QUEEN VICTORIA MARKET  
65-159 VICTORIA STREET MELBOURNE,  
MELBOURNE CITY VHR H0734

Officer's report and recommendation

Heritage permit application  
P36779

Figure 11: Most recent render of proposed laneway between Franklin Street Stores and the proposed new development. (Source: OVGA Workshop 4, Lendlease presentation)

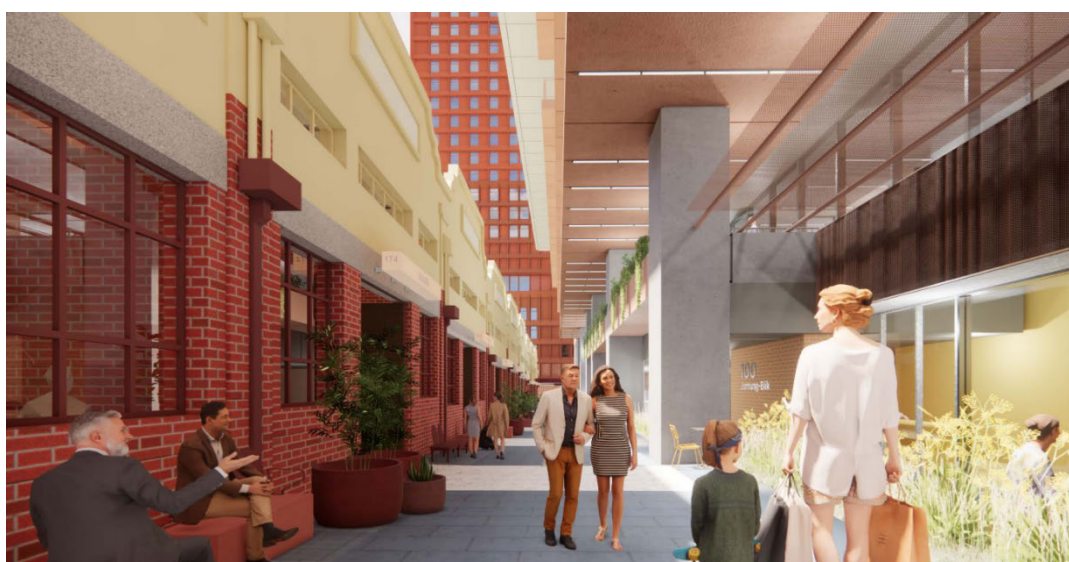
At present the extent of canopy proposed to be removed is unclear and inconsistent in the submitted architectural drawings. Should a permit be issued, it would be expected that an appropriate design solution is achieved through permit conditions. It would be expected that priority is given to retaining as much as possible of the canopy. A further condition should require that the full extent of the canopy is interpreted on the face of the Stores, in the paving below and in any other appropriate way. The paving proposal for the ground plane below the canopy submitted with the application incorporates nine different finishes including six different sizes of bluestone. This does not sufficiently reflect or interpret the canopy or the historic functional use of this space. While the proposal has been simplified during the course of the OVGA workshops, should a permit be issued, it would be expected that the proposed treatment was simplified to reflect the canopy and the historic use of the place. Paving and other treatments should be a continuation of those proposed in Market Square.

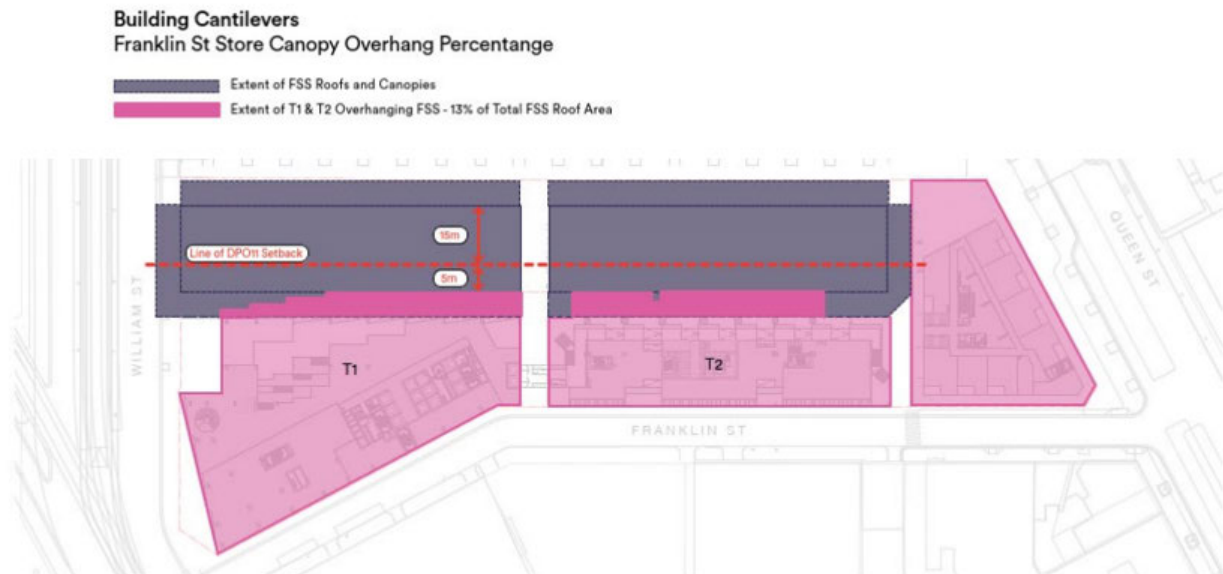
Towers One and Two cantilever over the Franklin Street Stores and are therefore partially included in the extent of registration for QVM. The cantilever is limited to the area above the canopy on the southern side of the Franklin Street Stores. It is acknowledged that DPO11 allows for a greater area of cantilever (c. 34% encroachment of the roof area) and the proposed encroachment is c. 12% of roof area.

Figure 14: Section of Tower One looking west indicating the extent that the tower extends above the canopy of the Franklin Street Stores. (Source: Tower One architectural plans)

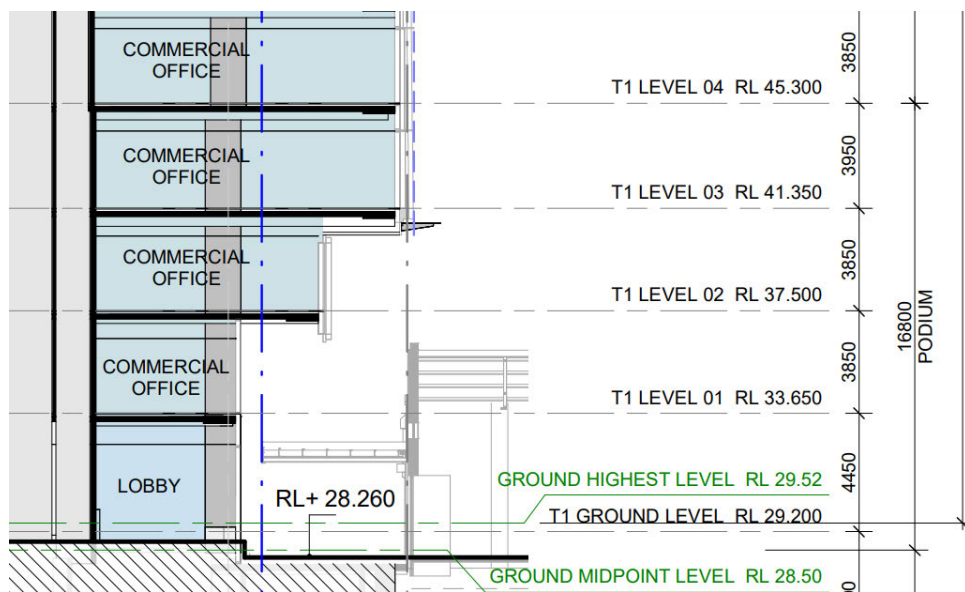
Tower One partially cantilevers over the western section of the Franklin Street Stores, to the full depth of the canopy. The cantilever is 2.564 metres above the Store's parapet at the western end and 4.06 metres at the eastern end. The north-western corner of Tower One peels away from the Stores, allowing for views to the Stores from William Street.

The reporting officer questioned the need for Tower One to cantilever over the Franklin Street Stores during the OVGA workshops. The architects advised that the proposal would be unviable without it. They also advised that if the cantilever was removed, the space would have to be made up elsewhere, most likely through additional built form at the north western corner, which is outside of the extent of registration. This would block views to the Stores when approaching from the south along William Street.

Although it would be preferable that Tower One did not cantilever over the Stores, the impact in the context of the towers themselves is limited. The towers will be constructed regardless of whether approval is given for a portion of them to cantilever over the Franklin Street Stores. In long views from the north, whether the towers cantilevers over the canopy or not will be indiscernible. On balance, the reporting officer is of the view that a cantilever over the southern canopy would be preferable to increased built form at ground level to the west of Tower One.

Figure 16: Left: Tower One typical floor plan. The red square indicates area where additional built form would be located should the cantilever not be approved. (Source: Lendlease (undated) Queen Victoria Market – Southern Development Site Project Feasibility – Tower 1 and Tower 2)

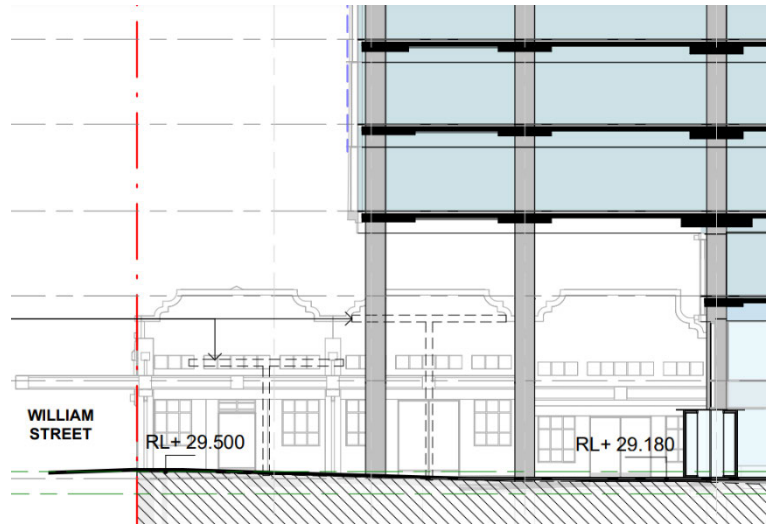
A reduction in the floor plate by removal of the cantilever would likely result in the removal of balconies and planters and the creation of a smoother facade. The 'roughness' created by the solids and voids of balconies and planters in the façade contributes to mitigation of wind impacts on the Stores. Should the tower be reduced in width, the balconies and planters would likely be removed or decreased in size, potentially requiring further strengthening of the Stores due to increased wind impacts.

Figure 20: Typical tower floorplate for Tower Two residential building. The red line indicates the extent of registration for QVM. (Source: Lendlease (undated) Queen Victoria Market – Southern Development Site Project Feasibility – Tower 1 and Tower 2)

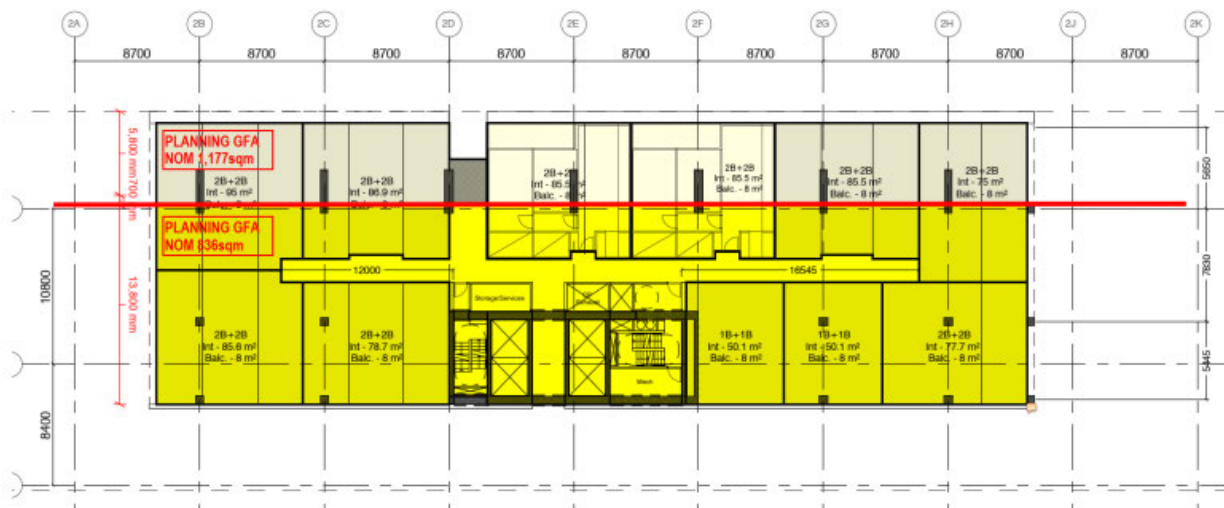
Figure 19: Cross section through Tower Two with the Franklin Street Stores at left. The wind canopy is not indicated, but the north face of the tower stops short of the parapet of the Stores. Mandatory setback above the podium under DPO11 is indicated at right. Because of this, the tower cannot be shifted back further to the south.

The cantilever of Towers One and Two originally aligned with the parapet of the Franklin Street Stores. This was of concern to the OVGA panel as rainwater from the towers would drip/cascade onto the parapet causing the potential for damage. The design team responded to this and the 'northern tower facade was shifted 700mm back from the southern parapet line of the Franklin Street Stores to remove the tower drip line over the heritage parapet.<sup>13</sup>

Figure 22: Cross section through Tower One with Franklin Street Stores at right. The possible wind canopy is indicated in the centre of the diagram. (Lendlease presentation OVGA Workshop 3, p. 30)

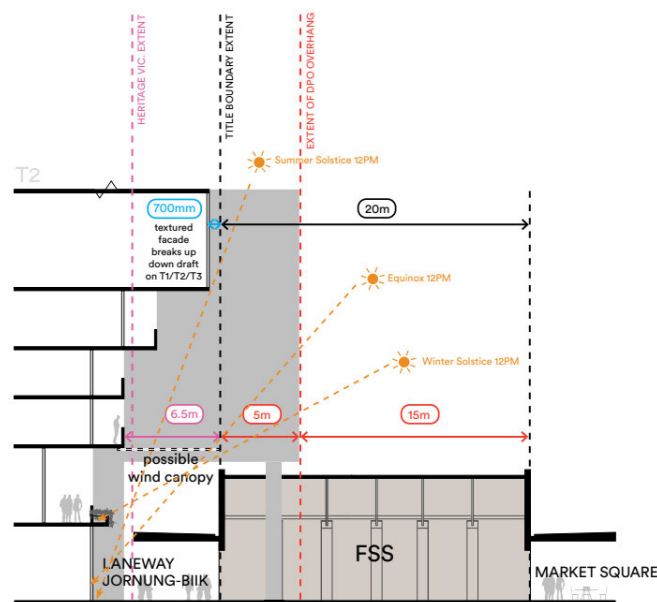
In relation to wind impacts, the proposed towers would form a new northern edge to the CBD and would be the first elements wind from the north would encounter. This would cause downdrafts onto the Franklin Street Stores and the proposed Market Square. The tower design proposes to include wind mitigation measures including a 'lip' or wind canopy at the base of the towers. This was discussed at OVGA Workshop Two and an indicative location for a possible wind canopy for Tower Two was included in Workshop Three documentation.

In the documentation submitted with the permit application, the alignment of the north façade of Tower Two was shifted back from the parapet however Tower One appeared to extend beyond the parapet by 250mm and a wind canopy at Level 3 extended out from the façade for a further 1500mm above the Stores proper. This extension of the building or the wind canopy further into the airspace was not discussed at OVGA workshops or in pre-application meetings and no reasons for the change was provided. Further encroachment into the airspace above the Stores would be unlikely to be supported. In information supplied in the response to a request for further information of 22 November 2023, the applicant advised that the extent of the cantilever had been reduced by c. 9%. This is a positive heritage outcome however the size and location of the 'lip' or wind canopy remains unclear. Should a permit be issued, a condition should be included to require to the final design of these elements. The condition should require submission of detailed design drawings prior to the submission of construction ready drawings. Sufficient time should be provided to allow for discussion and comment on the changes.
